WILLIAMSON COUNTY, TEXAS

CHANGE ORDER NUMBER: 1

CR 404 Hutto Water Line Williamson County Project No. T5045

Change Order No. 1 Reason for Change

SHEET
 C-100
 4 of 66

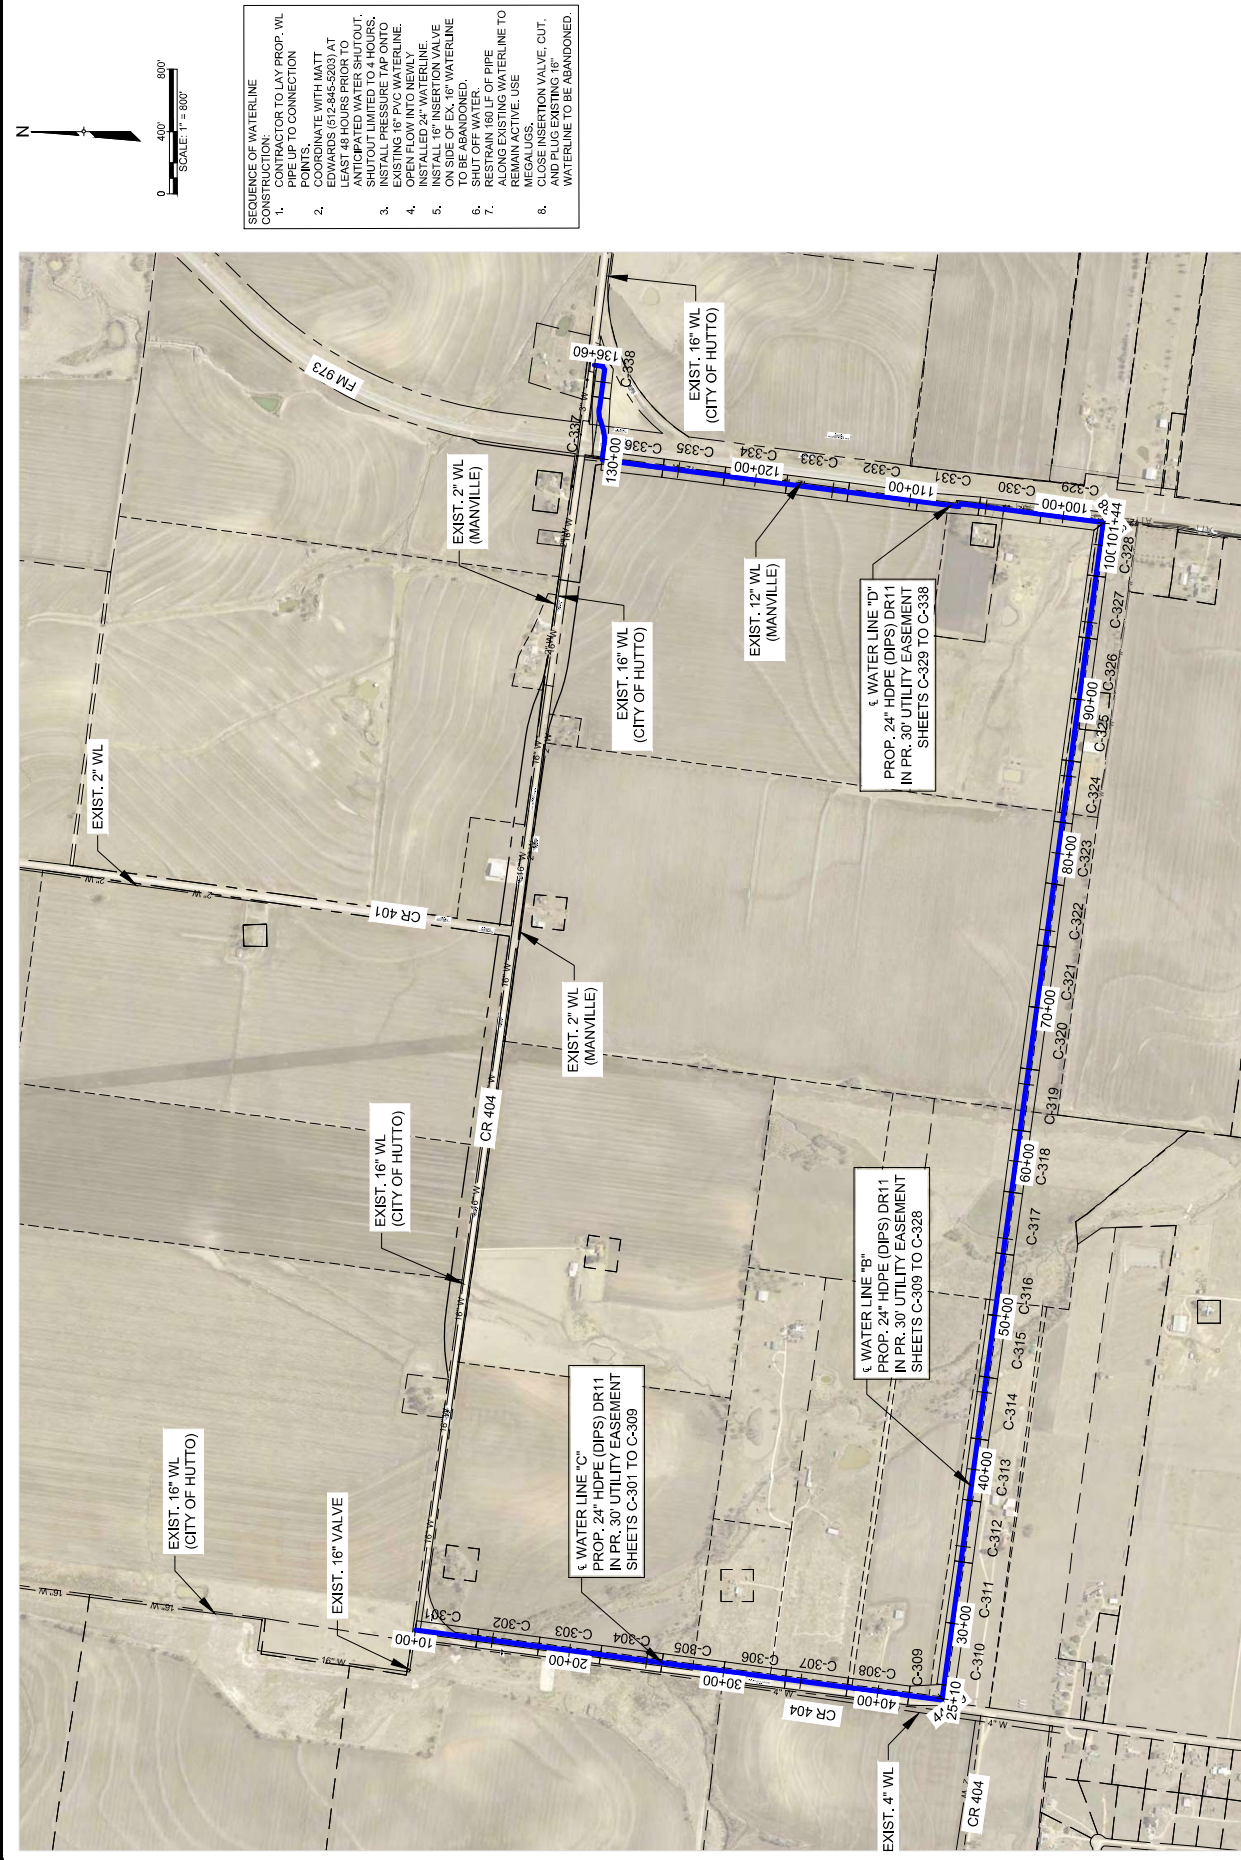
3F. County Convenience. Additional work desired by the County. This Change Order revises the original water line pipe design from 18 inch ductile iron to 24 inch HDPE pipe. Due to the Contract value of this requested change, the 24 inch HDPE pipe material and the fusion of that pipe is also being removed from this Contract and will be bid under a separate Contract. Portable concrete traffic barrier (CTB) is also being added to the Contract, to improve the work zone safety.

- 6. Work to be performed in accordance with Items: See attached.
7. New or revised plan sheet(s) are attached and numbered: C-002, 003, 100, 301 to 338, 401 and 501 to 503
8. New Special Provisions/Specifications to the contract are attached: Yes No
9. New Special Provisions to Item N/A No. N/A, Special Specification Item N/A are attached.
